**SECTION 00 9121**  
**REBID ADDENDUM NUMBER 1**

**DATE: November 18, 2016**

**RSMP Phase 2A REBID**  
**James Monroe High School**  
**RFI LOG**  
11/17/16

**RCSD  
James Monroe High School  
Rochester Schools  
Modernization Program**

ADDSK-A-17

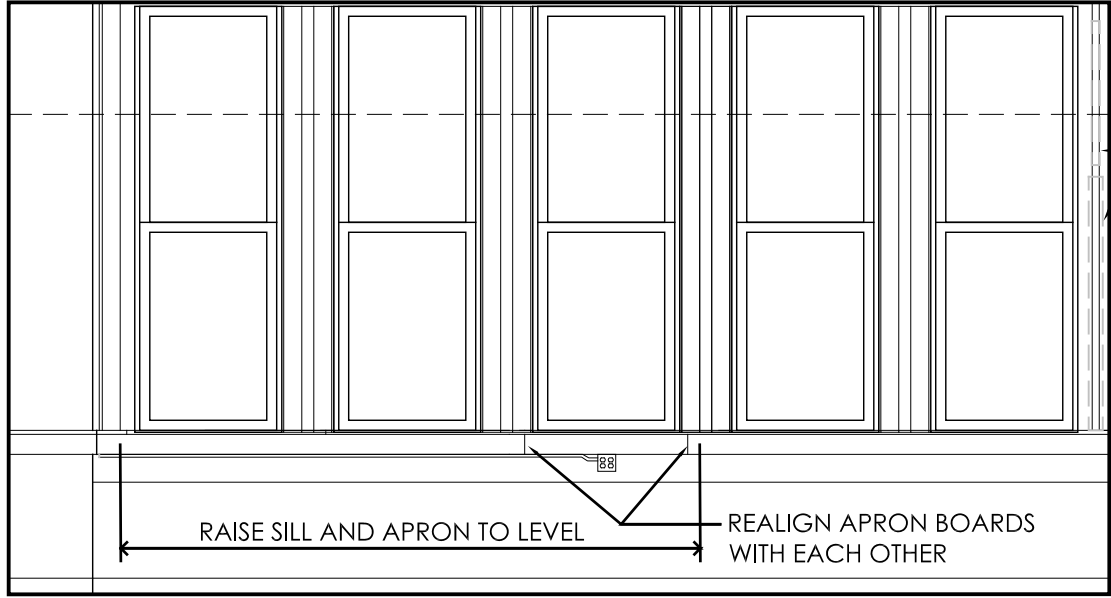
- A. Provide Stair 12A ceiling per ADDSK-A-17.

ADDSK-A-18

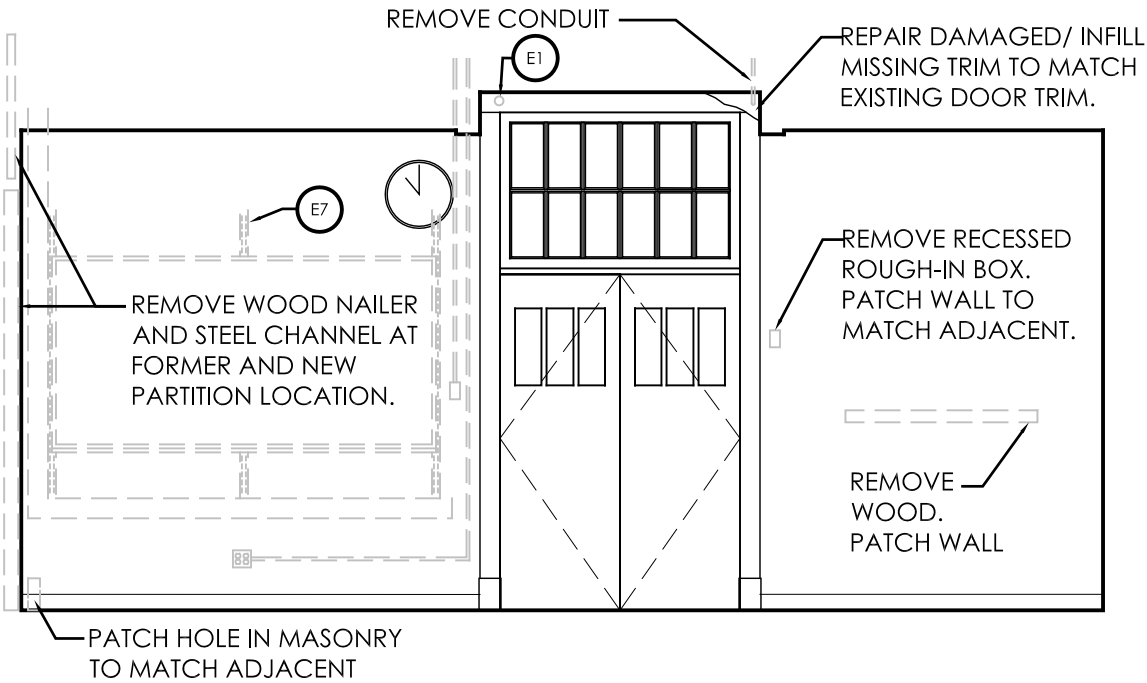
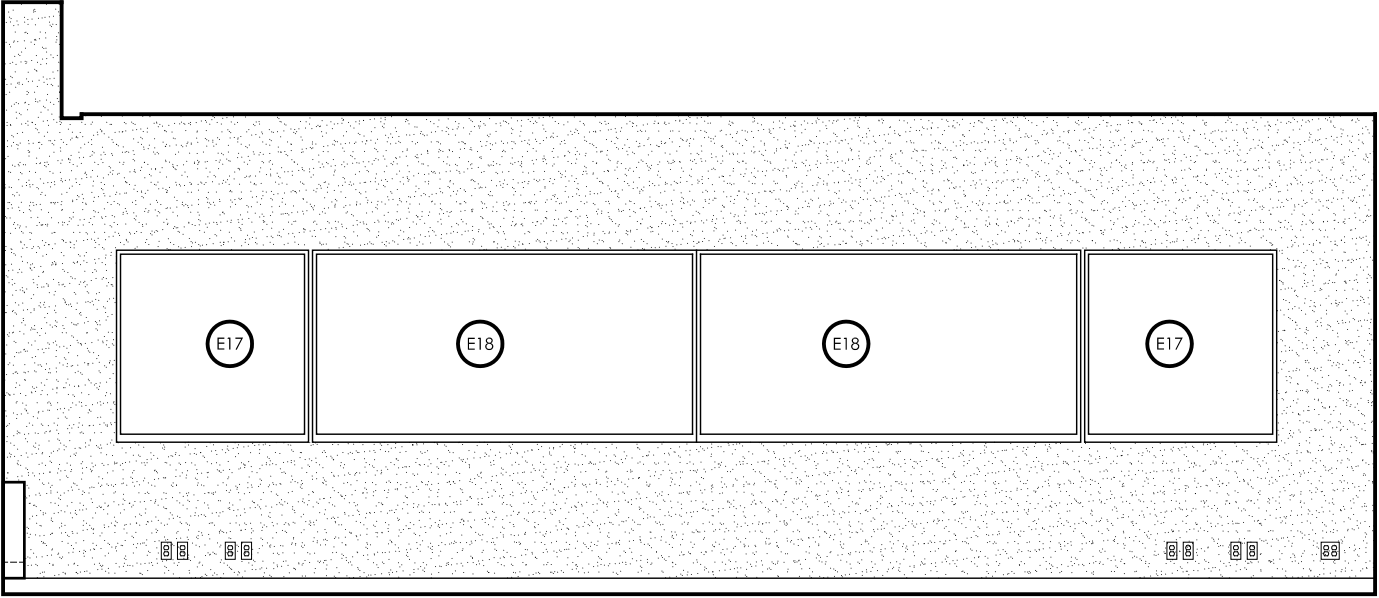
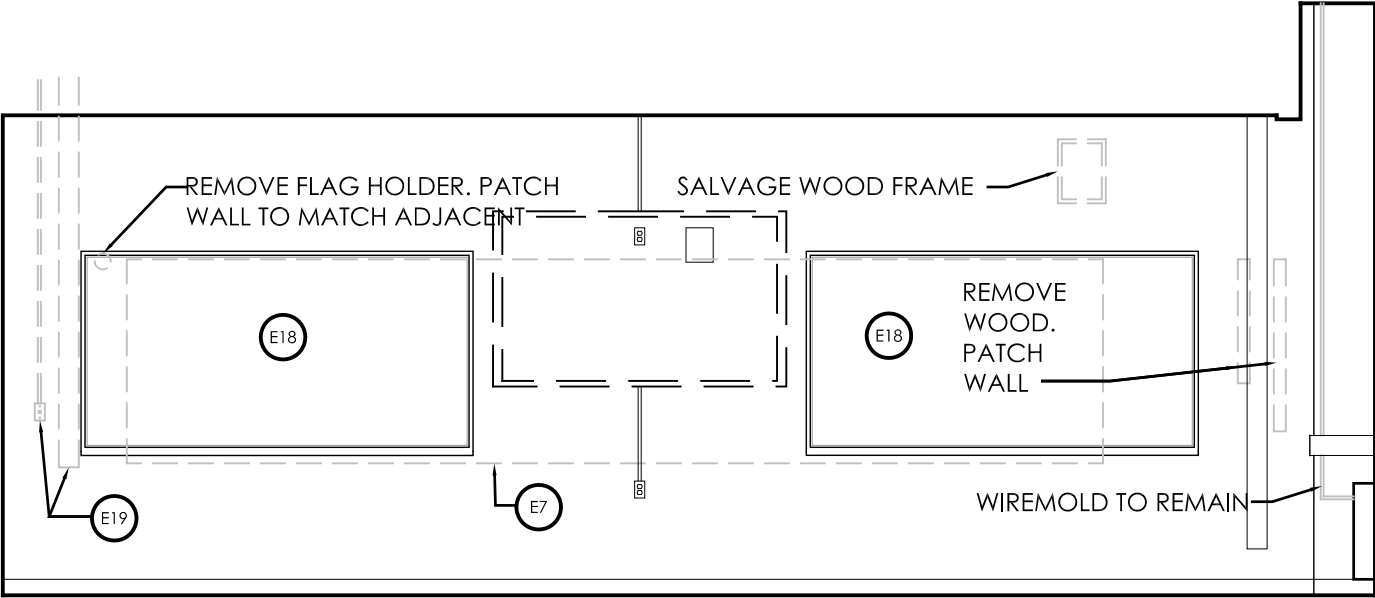
- A. Replace room elevations 2/A308 and 3/A308 for rooms 125 and 126 with the attached sketches ADDSK-A-18 and ADDSK-A-19 respectively.

REMOVE WOOD NAILER  
AND STEEL CHANNEL AT  
FORMER AND NEW  
PARTITION LOCATION.

RAISE SILL AND APRON TO LEVEL

REALIGN APRON BOARDS  
WITH EACH OTHER

REMOVE CONDUIT

REPAIR DAMAGED/ INFILL  
MISSING TRIM TO MATCH  
EXISTING DOOR TRIM.

REMOVE RECESSED  
ROUGH-IN BOX.  
PATCH WALL TO  
MATCH ADJACENT.

REMOVE  
WOOD.  
PATCH WALL

REMOVE WOOD NAILER  
AND STEEL CHANNEL AT  
FORMER AND NEW  
PARTITION LOCATION.

PATCH HOLE IN MASONRY  
TO MATCH ADJACENT

MAIN ENTRANCE AND STAIR SNOW MELT SYSTEM  
SCALE: 1/8" = 1'-0"

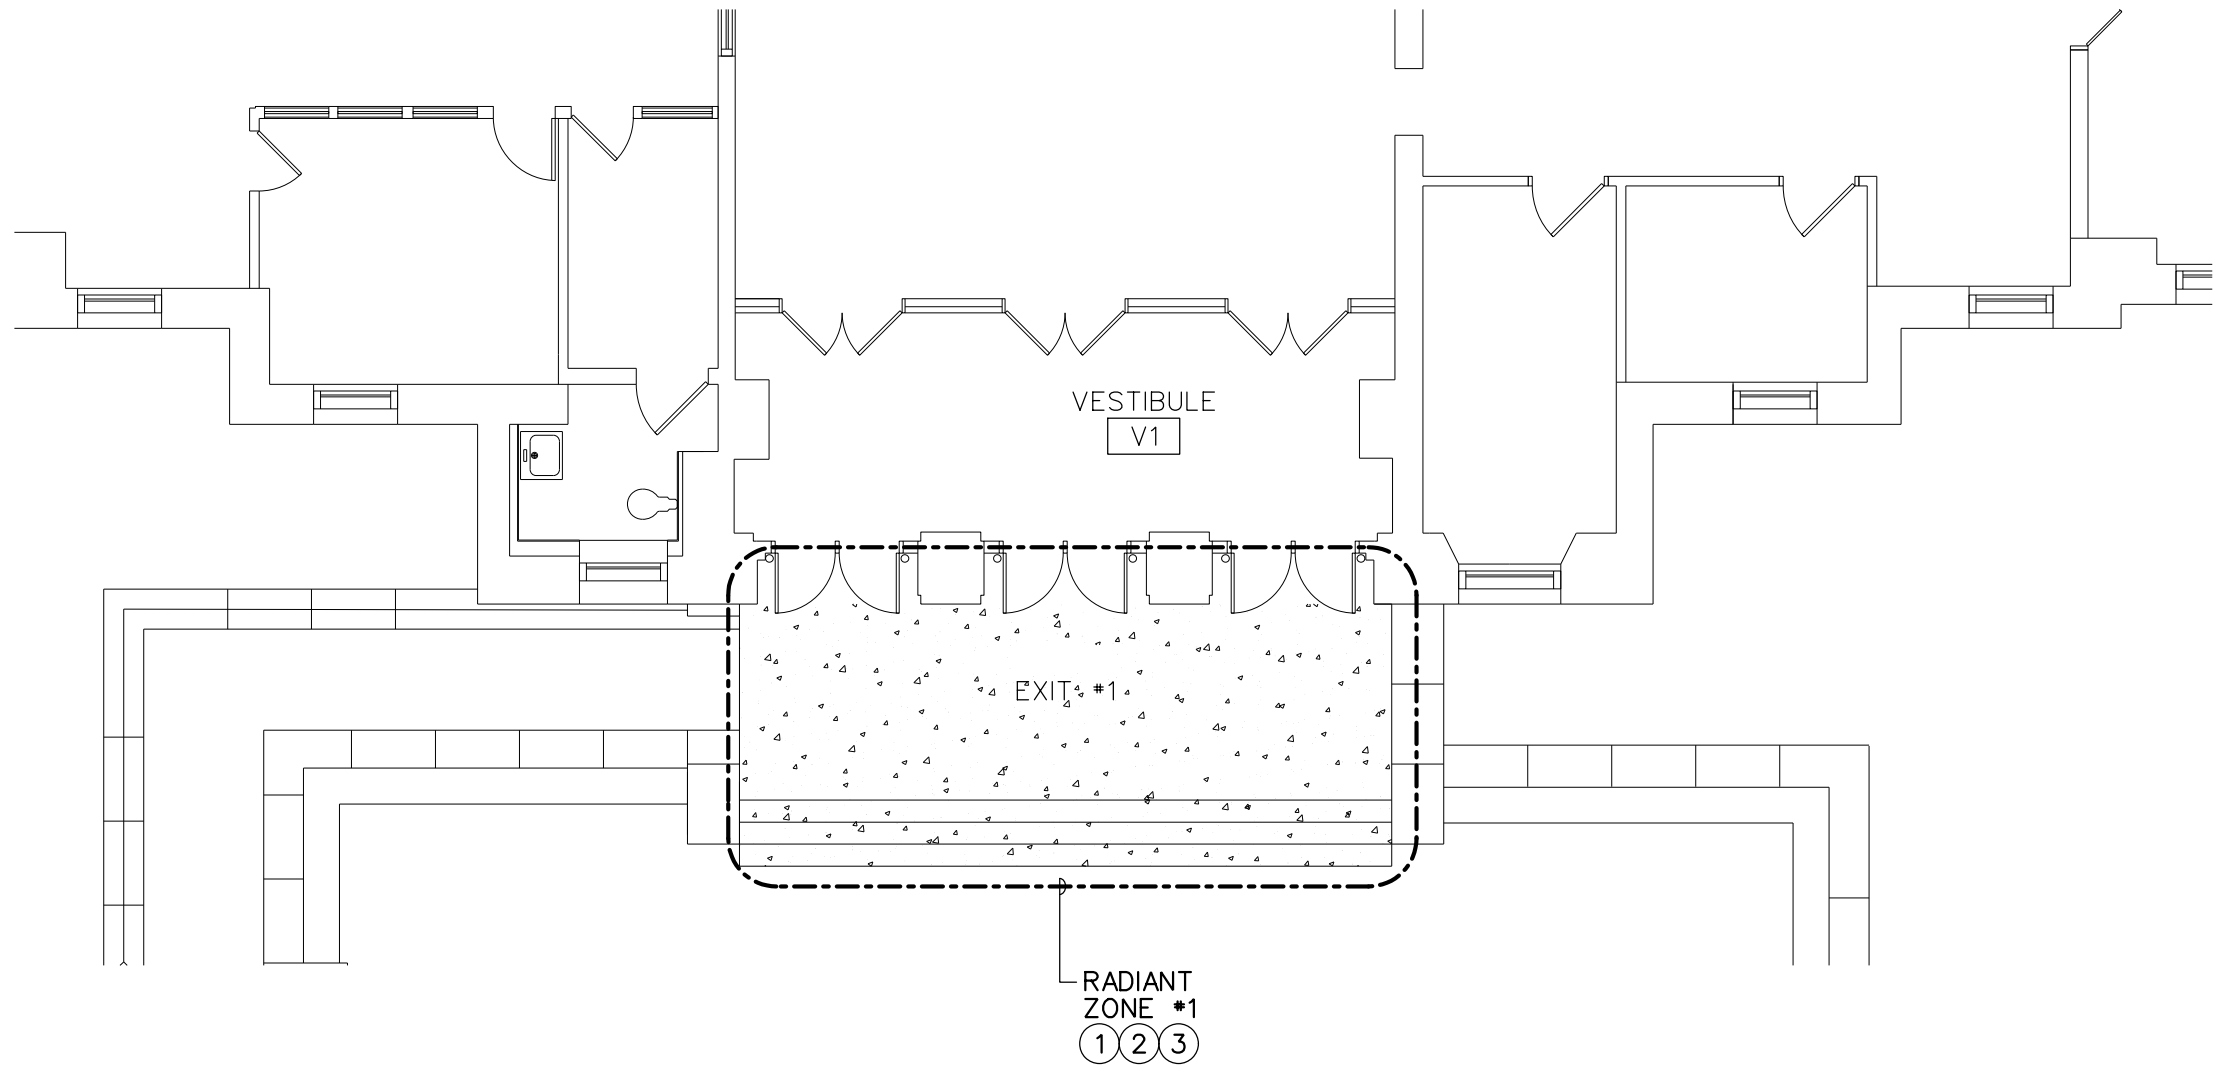
- A. Provide a snow melt system to the entrance landing and steps per ADDSK-A-21.

- A. THIS CONCEPT OF THIS SKETCH IS TO ADD RADIANT TUBING TO THE MAIN ENTRANCE AND STAIRS.

PROVIDE RADIANT SNOW MELT TUBING IN THE MAIN ENTRANCE LANDING AND STAIRS.
- ②

THE TUBING SHALL BE INSTALLED AND TERMINATED AT THE MANIFOLD IN THE CRAWL SPACE BELOW. LOCATE THE MANIFOLD IN CRAWL SPACE CS, REFER TO DRAWING LS100 FOR CLARIFICATION. SYSTEM TO BE CAPPED FOR FUTURE CONNECTION TO THE BUILDING HEATING SYSTEM.
- ③

PROVIDE A 1" CONDUIT IN THE SLAB FOR INSTALLATION OF THE SLAB MOUNTED CONTROL SENSOR. THE CONDUIT SHALL TERMINATE IN CRAWL SPACE CS, ADJACENT TO THE MANIFOLD. COORDINATE WITH DAY AUTOMATION FOR LOCATION OF THE SLAB SENSOR.

## TYPICAL DOOR BULKHEAD DETAIL

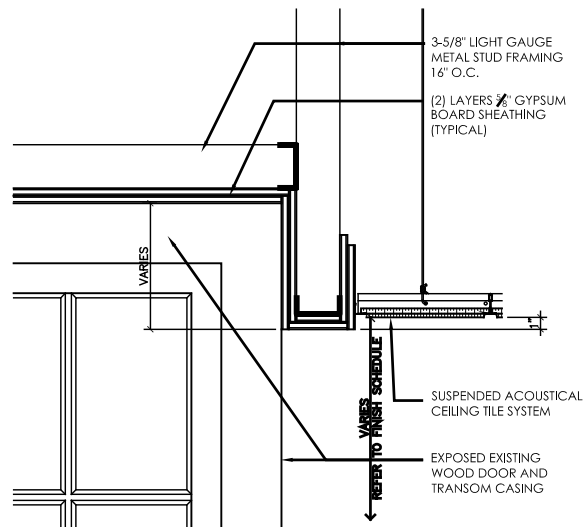
- A. Replace detail 5/A307 in its entirety with ADDSK-A-22.
